# Groundwater Application Review Summary Form

Application # G- 18437

GW Reviewer Aurora Bouchier Date Review Completed: 5/23/2017

Date: May 23, 2017TO: Application: G-18437FROM: GW: Aurora Bouchier  
(Reviewer's Name)SUBJECT: Scenic Waterway Interference & General/Local Surface Water  
Evaluation for Deschutes Ground Water Study Area

Water-Level Trends in Nearby Wells

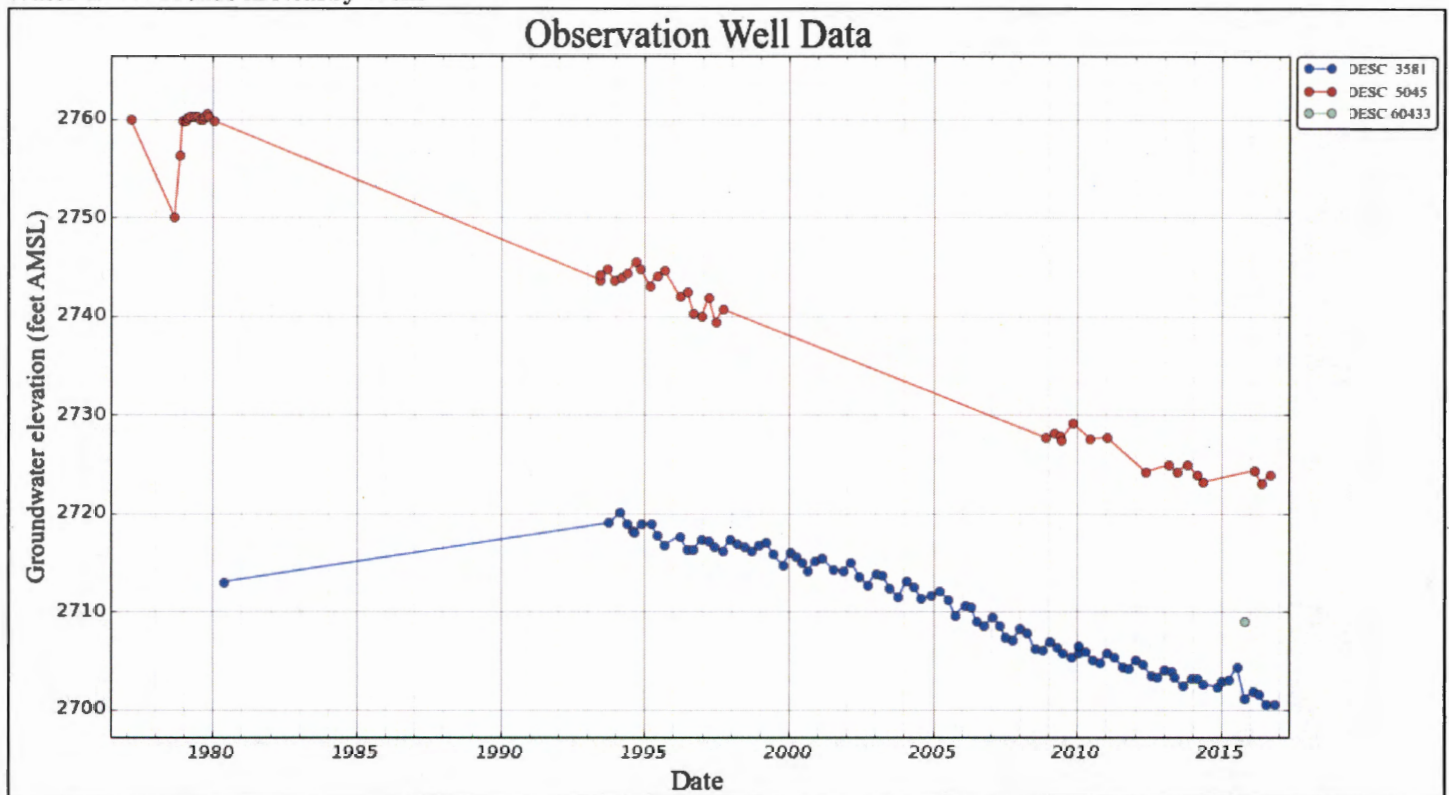
B3. **Groundwater availability remarks:** The nearest, relevant, State Observation Wells are DESC 3581 (located approximately 5.4 miles to the northeast) and DESC 5045 (located approximately 8 miles to the southeast). Both DESC 3581 and DESC 5045 have been monitored periodically since at least the 1990's. Both wells show a relatively steady decline since 1994 to present. The water levels have dropped approximately 20 to 22 feet, likely mainly due to decreased recharge but also due to increased pumping.
